**UNIVERSITY OF HAWAII,
INSTRUMENTATION DEVELOPMENT
LABORATORY**

**STURM2 ASIC BOARD
REVISION C**

CHANGES IN REVISION C

ASIC BOARD MOUNTED ONTO POWER BOARD

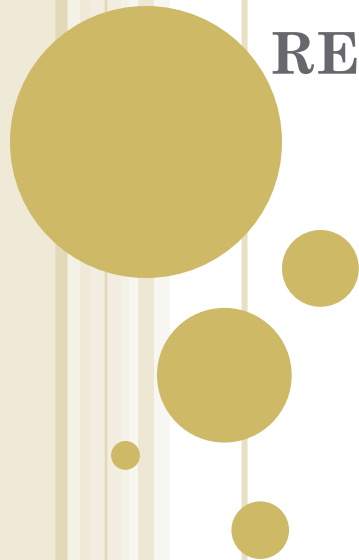
- PCI connectors changed to single 90 degree angle press fit connector
- ASIC board will be at 90 degree angle against the power board to save space
- Signal input method changed to UMCC connectors
